DEVELOPMENT APPLICATION ASSESSMENT REPORT

Application Number:	DA2022/1719
---------------------	-------------

Responsible Officer:	Megan Surtees
Land to be developed (Address):	Lot 6 DP 8260, 150 Queenscliff Road QUEENSCLIFF NSW 2096
Proposed Development:	Alterations and additions to a dwelling house.
Zoning:	Warringah LEP2011 - Land zoned R2 Low Density Residential
Development Permissible:	Yes
Existing Use Rights:	No
Consent Authority:	Northern Beaches Council
Delegation Level:	DDP
Land and Environment Court Action:	No
Owner:	Antony Graham Clarke Christina Marie Clarke
Applicant:	Antony Graham Clarke

Figure 1. Maximum building height breach.

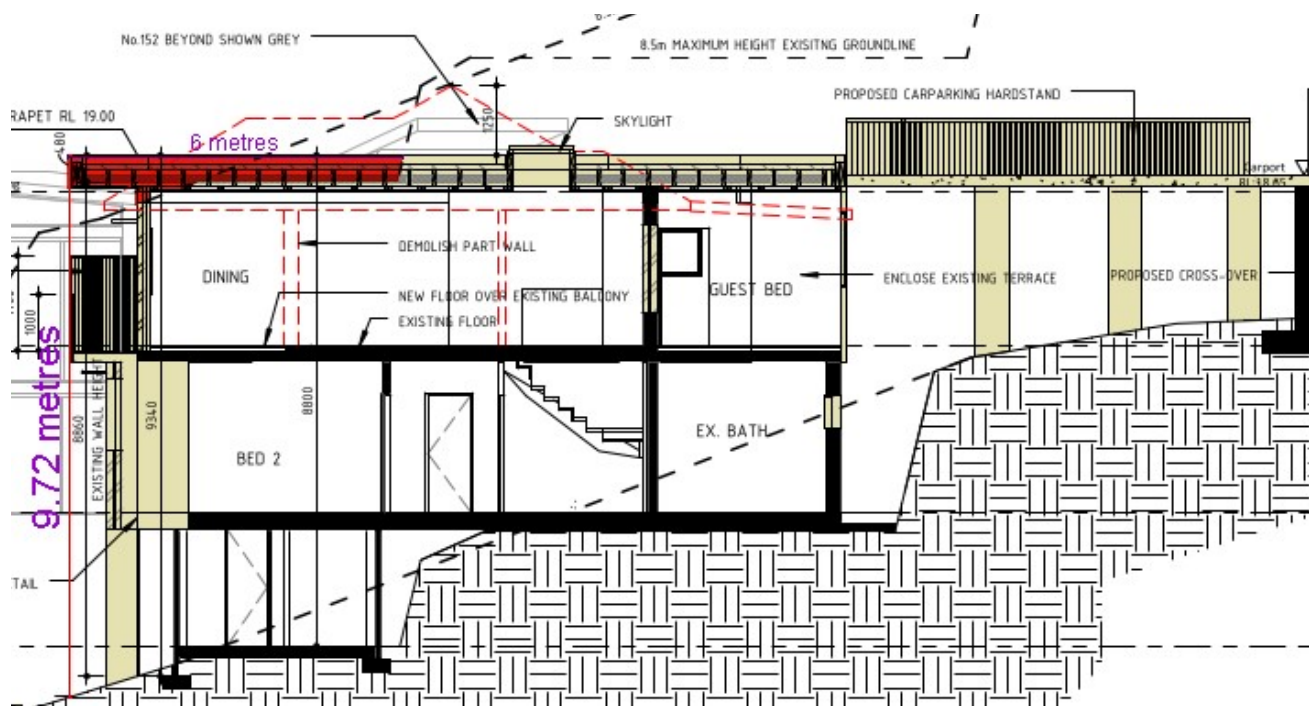
Description of non-compliance:

Development standard:	Height of buildings
Requirement:	8.5m
Proposed:	9.72m
Percentage variation to requirement:	14.1%

The scope of non-compliance is sited to the principal dwelling for a length of 6.0 metres and is sited entirely to the roof form over the dining room and balcony located off the dining room (along the southern elevation) (as indicated in red in Figure 1, above), where the site slopes with the existing excavation and topography of the land. As the scope of non-compliance is setback 16.25 metres from the front boundary line, and 13.6 metres from the secondary frontage, the non-compliance is unlikely to be easily discernible from the dual street frontages. Notwithstanding the non-compliance, when viewed from Aitken Avenue, the building mass of the proposed principal dwelling will not be dissimilar to the buildings located within the visual catchment adjoining the subject site (being 152 Queenscliff Road to the west of the subject site, and 146-148 Queenscliff Road to the east of the subject site). In this instance, the overall building height will not adversely or unreasonably impact upon the existing character of the streetscape of both Queenscliff Road and Aitken Avenue.

It is considered that the Applicant's reasoning to vary Clause 4.3 Height of Building of the Warringah Local Environmental Plan 2011 (WLEP 2011) is acceptable given the site experiences a substantial slope, falling from the northern boundary at Queenscliff Road toward the southern boundary at Aitken Avenue. Additionally, the site has experienced substantial excavation over the years that has

Figure 2. Eastern elevation wall height breach (indicated in pink).

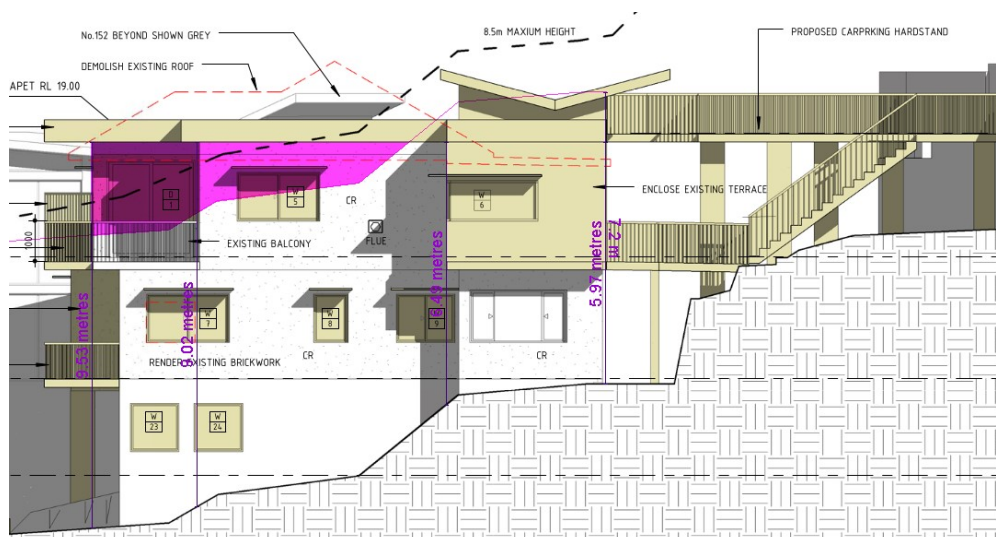
This control requires development to result in a maximum wall height of 7.2 metres. The proposed development will result in a dwelling that exceeds the maximum wall height requirement along both the eastern and western elevations, as indicated in the figures below.

An exception may be permitted which allows the requirements of this control to be varied on sites with slopes greater than 20% below the building footprint, provided that the building does not exceed 8.5 metres, is designed and located to minimise the bulk and scale and has a minimal visual impact when viewed from the downslope sides of the land. As the proposed maximum height exceeds 8.5 metres, the exception cannot be applied, notwithstanding the fact the building footprint is sited on a slope of approximately 39.9% along the western elevation and 28.5% along the eastern elevation.

The existing dwelling ranges between two (2) and three (3) storeys where the land significantly slopes to the south. The existing site constraints and the siting of the dwelling means that strict compliance with this control is difficult. Amended plans were received which removed the proposed secondary dwelling. As amended, the visual impact of the built form of the dwelling is consistent with the existing built form of the dwelling on the subject site, and those of single residential dwellings on adjoining and surrounding properties. Further, the proposal includes replacement tree planting in the southern portion of the site (that is, between the dwelling house and garage), which contributes to providing visual relief of the built form when viewed from Aitken Avenue and the nearby waterway. The extent of non-compliance will not be discernible from the Queenscliff Road frontage.

Figure 4. Eastern side boundary envelope breach (indicated in orange; yellow indicates existing breach).

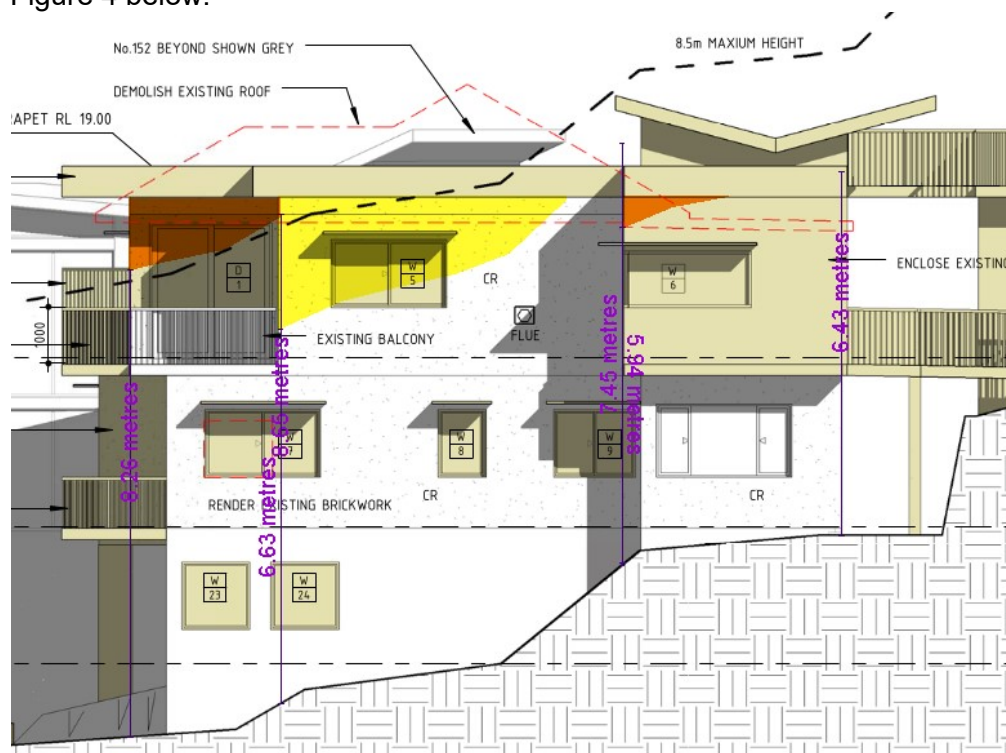
This control requires development to be sited within a side boundary envelope, which is measured at a height of 5.0 metres from the side boundaries, then angled inward at 45 degrees. The proposed development will encroach the side boundary envelope along the eastern elevation, as indicated in Figure 4 below.

As a direct result of the steep topography of the site, the rear portion of the proposed development (along the southern elevation) results in non-compliances to the requirements of the wall height, side boundary envelope and the maximum wall height. The extent of encroachment is minor and sited only to the eastern elevation, as indicated in Figure 5 above. The greatest encroachment is sited 3.25 metres from the eastern side boundary. In this instance, and by virtue of it's height and bulk, the proposed development is considered acceptable with no unreasonable amenity impacts upon adjoining properties and the subject site.
